UNITED STATES PATENT AND TRADEMARK OFFICE

APPLICATION NO.	FILING DATE	FIRST NAMED INVENTOR	ATTORNEY DOCKET NO.	CONFIRMATION NO.
10/612,274	07/02/2003	William A. Lane	T0461.70038 US00	4071
7590	09/22/2004			
Steven J. Henry Wolf, Greenfield & Sacks, P.C. 600 Atlantic Avenue Boston, MA 02210			EXAMINER ANDUJAR, LEONARDO	
			ART UNIT 2826	PAPER NUMBER

Office Action Summary	Application No. 10/612,274	Applicant(s) LANE ET AL.	
	Examiner Leonardo Andújar	Art Unit 2826

DETAILED ACTION

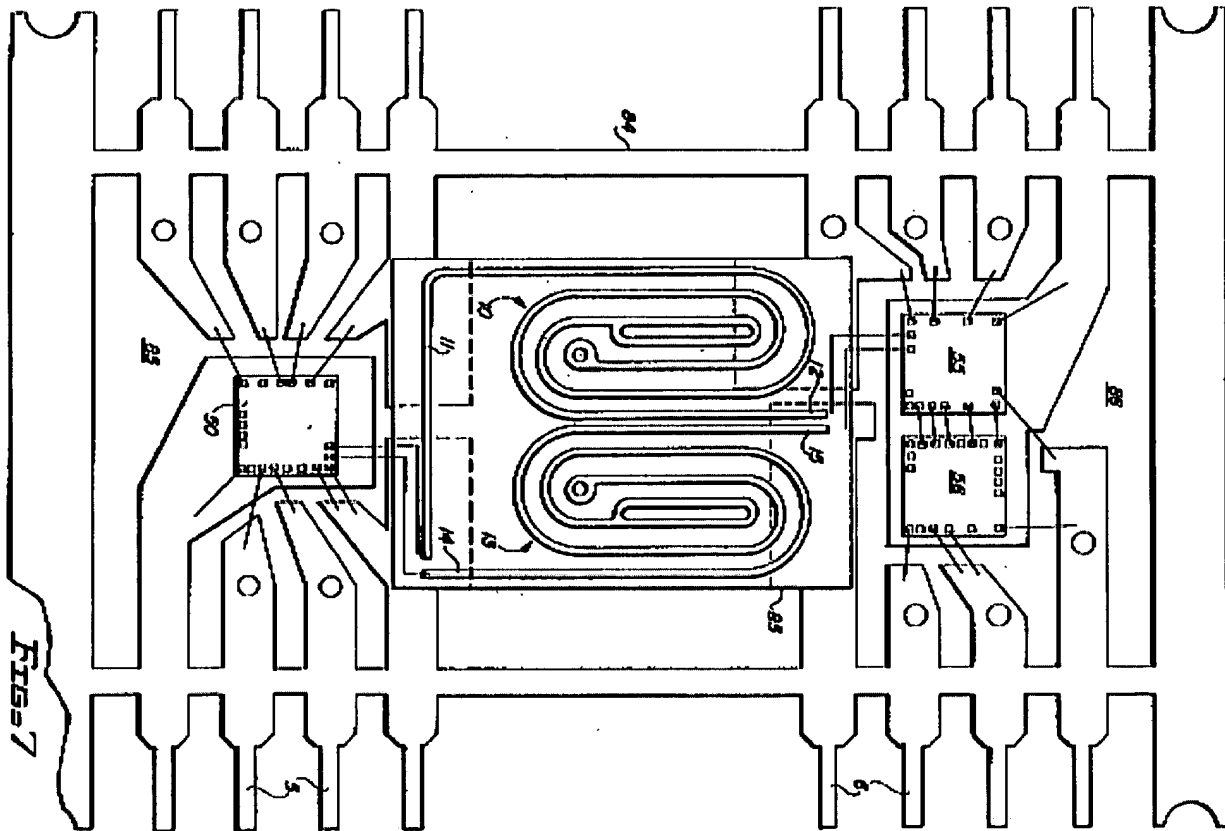
4. Regarding claim 1, Meinel (e.g. fig. 7) shows a package device having a patterned lead frame 84 with at least two isolated patterned dies 50/55 mounted thereon, the package device additionally having a transformer component. The component is individually mounted to the lead frame between the at least two patterned dies, the transformer adapted to provide to the selective coupling of energy between the dies (see claims 17 & 19).

7. Regarding claim 14, Meinel (e.g. fig. 7) shows a multi chip package device comprising a first chip 55, a second chip 50 and an isolating transformer component provided between the first and second chip (not shown in this figure). The first chip, the second chip and the transformer component are formed on segmented portions of a lead frame 84 of the package device. In this case, the inner segments of the leads are recognized as the segmented portions of the lead frame (see claims 17 & 19). Note that the chips, the substrate that contains the transformer are formed on the inner segments of the leads.

9. Regarding claim 17, Meinel shows a method of isolation components provided on a package multi chip device comprising the steps of: a) providing a patterned lead frame 84; b) mounting on the lead frame a plurality of patterned dies 55, 50; c) coupling energy between at least two of the patterned dies via an isolation transformer, the isolating transformer being provided on a separate component within the package to the dies being coupled (see claims 17 & 19). Note that the chips, and the substrate 85 that contains the transformer are provided in separate lead or components (see fig. 7).
